Request for Continued Examination (RCE) Transmittal

Application Number	10/798,693
Filing Date	03/11/2004
First Named Inventor	Stanton
Art Unit	3673
Examiner Name	LEE
Attorney Docket Number	CLPS-18789

RESPONSE TO OFFICE ACTION DATED JUNE 10, 2009

Amendments to the Drawings: Replacement Sheets for Figures 4, 6, and 12.

FIG. 4

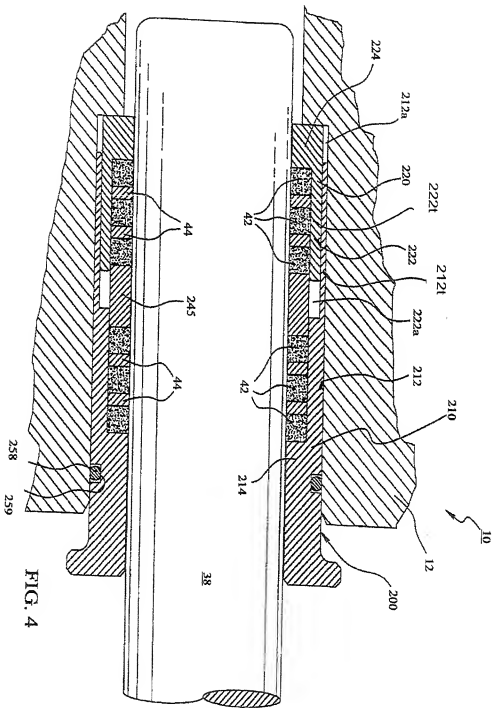
The drawings were objected to under 37 CFR 1.83(a) because the specific terms “telescoping structures” as used in the currently- pending claims were not identified in the drawings. Applicants amend as required by the Examiner.

Regarding Figure 4, Paragraphs 0145 and 0146 of the specification are amended to include the specific references 212t and 222t for the “telescoping structures” and Figure 4 of the drawing is amended to include these references. Further support for these amendments is found in the specification, for example, in Paragraph 0145:

[0145] As will be appreciated, the telescoping structures 212t and 222t of the first sleeve portion **212** and the second sleeve portion **222** allow for squeezing of the first abutment ring **214** and the second abutment ring **224** co-axially closer to one another after positioning the pre-assembled packing cartridge **200** on a plunger **38** in the packing bore **28**. This axial squeezing is initially provided by the gland nut **32** (not shown in **Figure 4**). The gland nut initially can be tightened to the specifications of the packing elements **42**. In addition, from time to time, the gland nut can be tightened further to further squeeze the packing elements **42** in compensation for wear during operation of the pump. Preferably, these telescoping structures 212t and 222t allow for at least sufficient overlapping travel in areas **212a** and **222a** to allow for the expected crushing of packing during the operation of a plunger **38** though the packing cartridge **200**. For example, the expected crush of the packing rings may be about 0.4 inches.

[0146] Preferably, a spacer ring **245** is positioned operatively to cover the overlapping travel of inwardly exposed area **222a** of the telescoping structures 212t and 222t between the first and second sleeve portions **210** and **220**. This spacer ring **245** helps prevent seepage of fluid into any clearances between the first sleeve portion **210** and the second sleeve portion **220**. The spacer ring **245** can also act as a back-up ring for the packing rings **42**.

FIG. 6

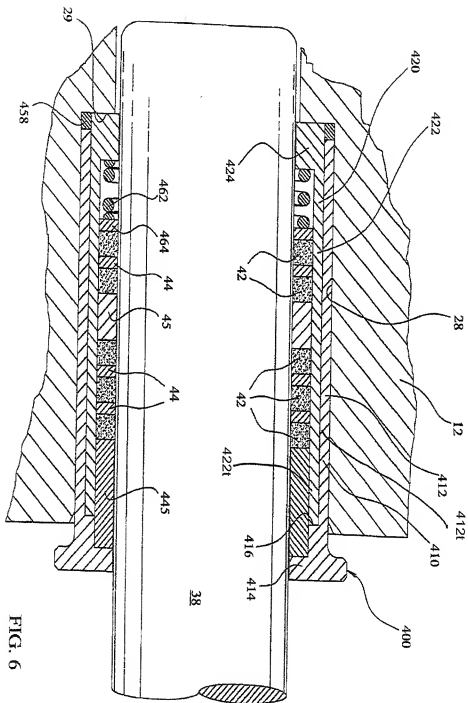
Regarding Figures 6 and 12, Paragraphs 0156 and 0158 of the specification are amended to include the specific references 412t and 422t for the “telescoping structures” and Figures 6 and 12 of the drawing is amended to include these references. Figure 12 is a cross-sectional view of another embodiment of a packing cartridge similar to the embodiment shown in Figure 7 (*See, e.g.*, Specification Paragraphs 0076 and 0193), where Figure 7 is a cross-sectional view of another embodiment of a packing cartridge similar to the embodiment shown in Figure 6 (*See, e.g.*, Specification Paragraphs 0068 and

[0156] Preferably, a spacer ring **445** is positioned operatively to cover the overlapping travel of the telescoping structures 422t and 412t between the first and second sleeve portions **410** and **420**. This spacer ring **445** helps prevent seepage of fluid into any clearances between the first sleeve portion **410** and the second sleeve portion **420**. The spacer ring **445** can also act as a back-up ring for the packing rings **42**.

[0158] As will be appreciated, the telescoping structures 422t and 412t of the first sleeve portion **412** and the second sleeve portion **422** allow for squeezing of the first abutment ring **414** and the second abutment ring **424** co-axially closer to one another after positioning the pre-assembled packing cartridge **400** on a plunger **38** in the packing bore **28**. However, in this embodiment, the packing cartridge **400** is positioned in the packing bore **28** and tightened by a gland nut (not shown) until the second sleeve portion **422** bottoms out against a shoulder **416** of the first sleeve portion **412**. In this position, the coil spring **462** is compressed with a packing assembly positioned between the first abutment ring **414** and a second abutment ring **424**. The advantage of bottoming out the telescoping structures 422t and 412t is that it prevents over-tightening of the packing cartridge **400** in the packing bore **28**. The spring **462** maintains a pre-determined amount of axial compression on the packing rings **42** of the packing stack.
